Addendum No. 1
Four Rivers Sanitation Authority
Lab Building HVAC Upgrades, Capital Project No. 2202

This Addendum Number 1, dated November 29, 2023, for the above referenced project, supersedes all contrary and conflicting information in the specifications and contract documents, which are hereby supplemented or revised as follows:

**Lab Building HVAC Upgrades
Capital Project No. 2202
Bid Doc. No. 23-412**

M2

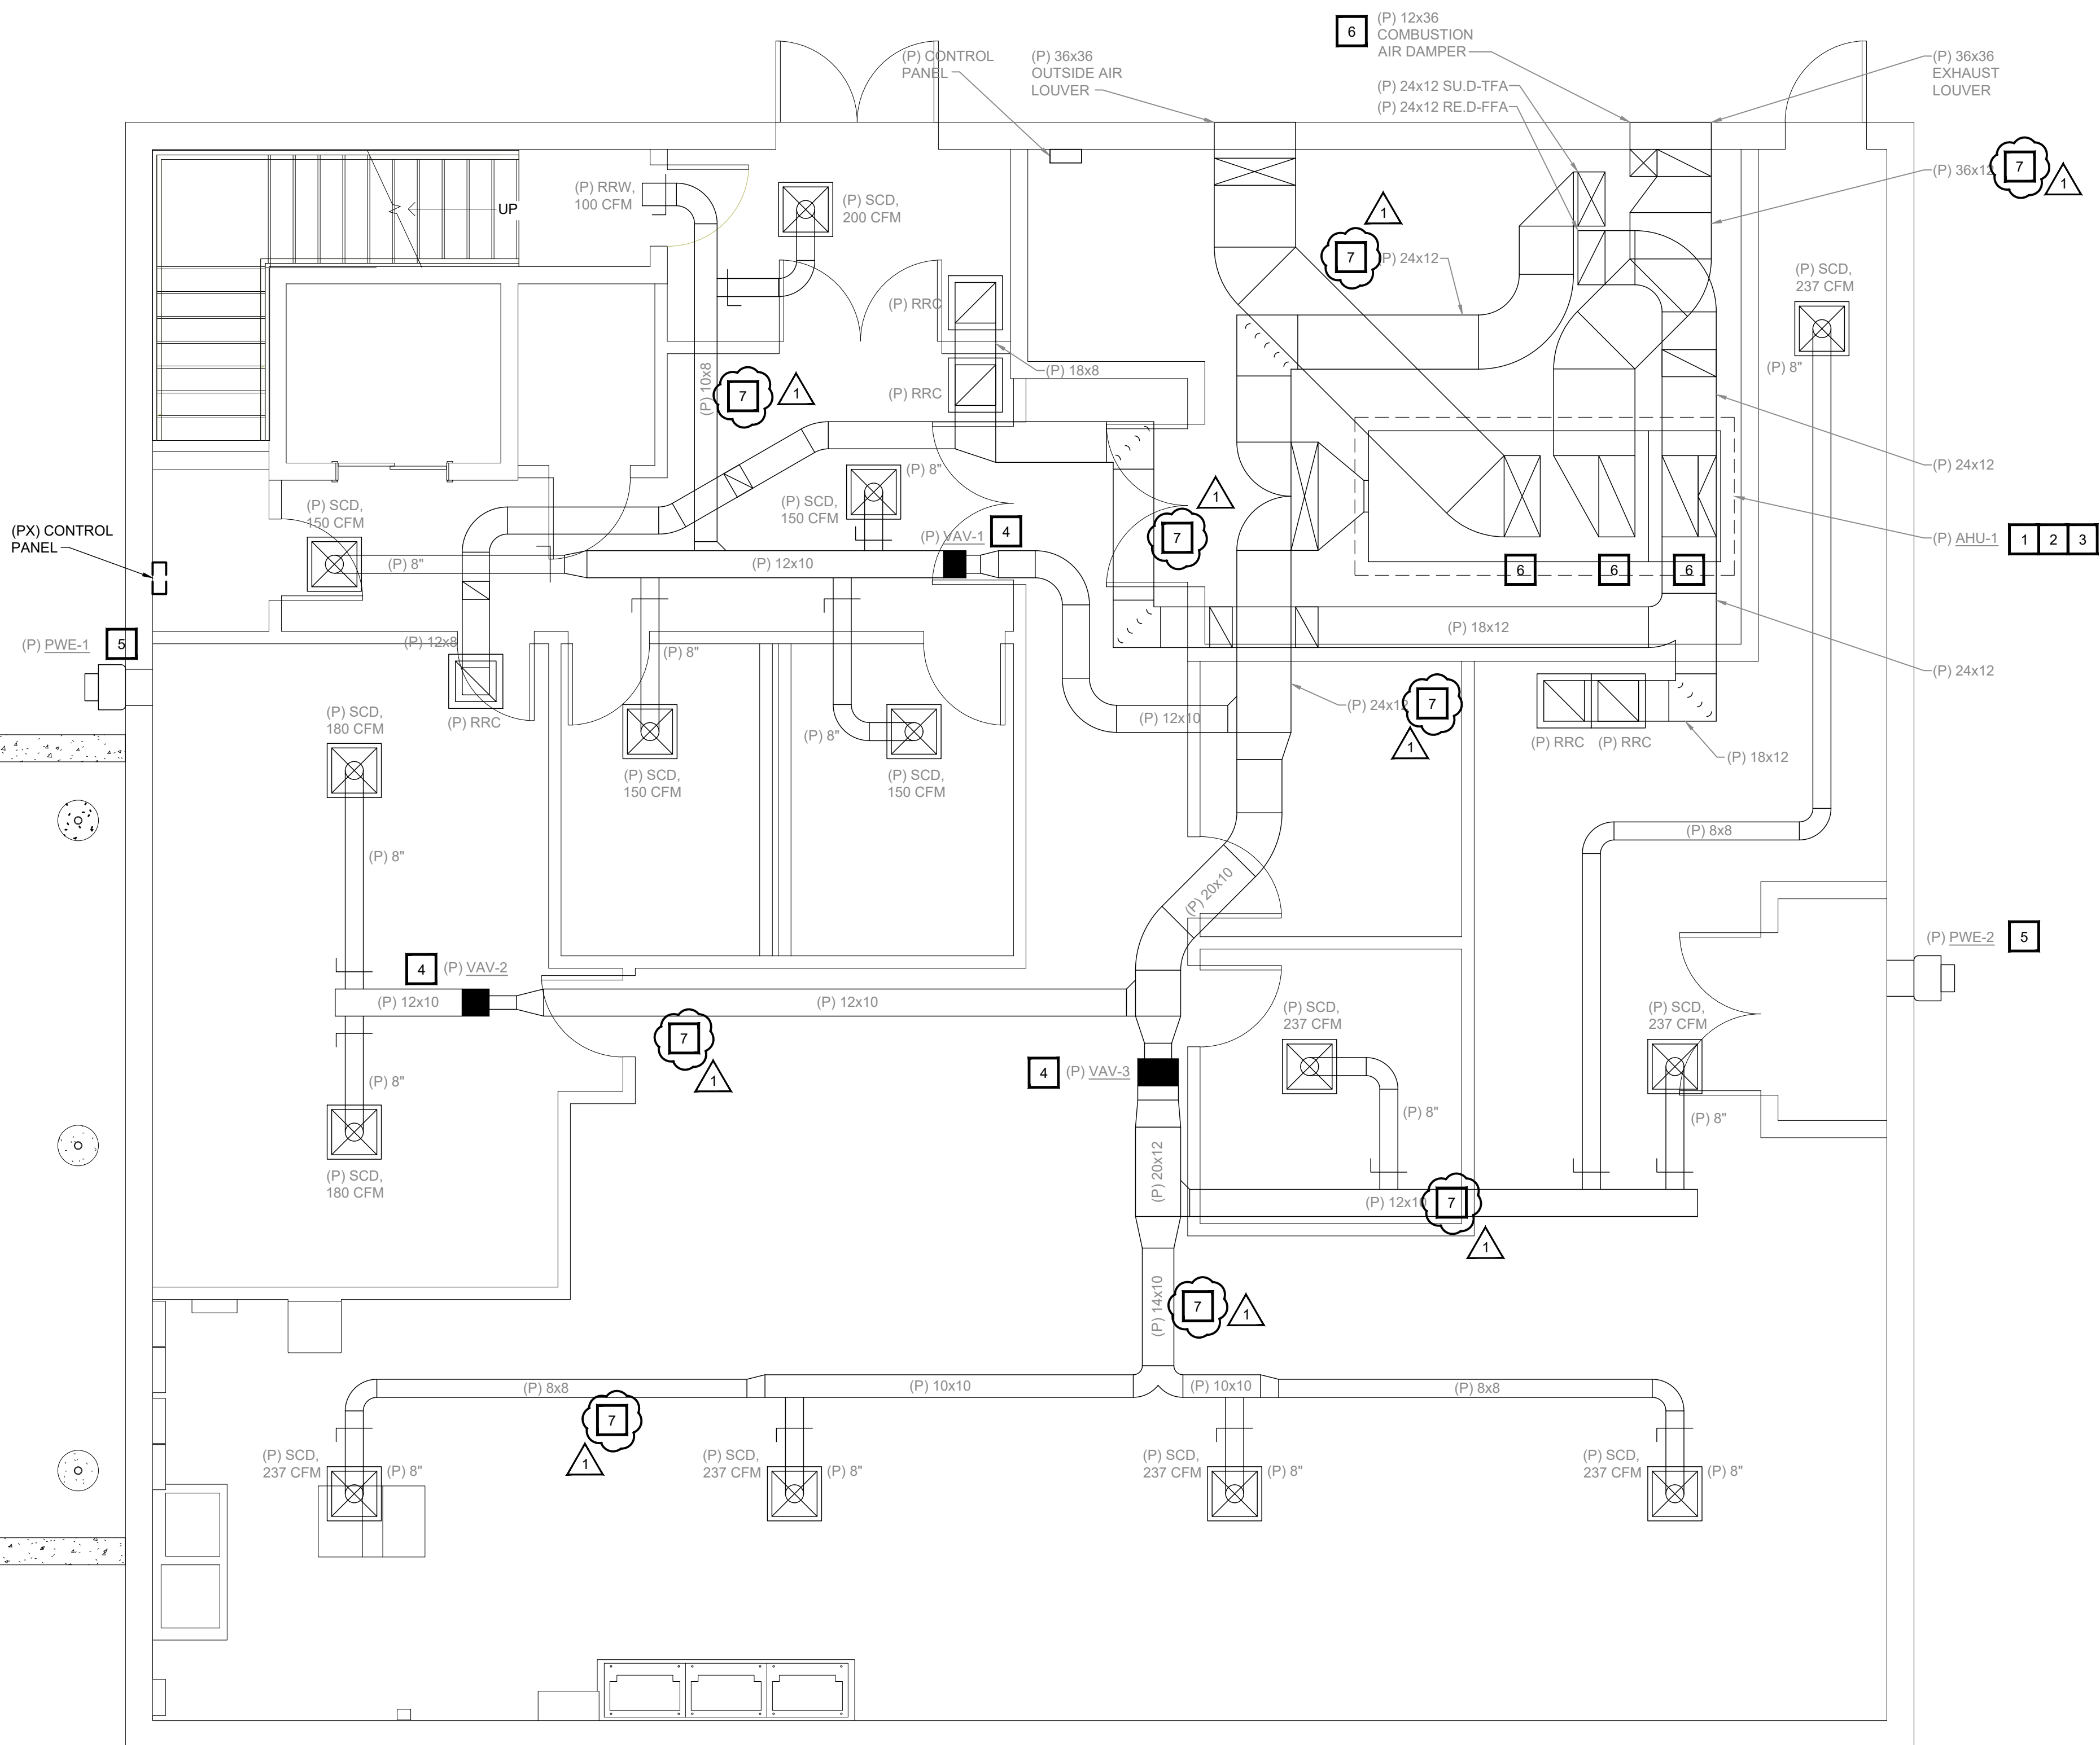
- Note the revised plan sheets show the routing of the refrigerant lines from the air handling unit in the boiler room to the condenser on the south side of the building. Any demolition of the refrigerant lines will require full restoration.
- The refrigerant lines are in a drywall chase and above the drop ceiling. Any removals of said drywall and drop ceiling shall be restored to original condition before being disturbed.
- Note all existing ducts shown shall be cleaned. See revised sheets M-2 and M-3.

7. EXISTING DUCTS SHOWN SHALL BE THOROUGHLY CLEANED, TYPICAL FOR ALL DUCTS SHOWN.
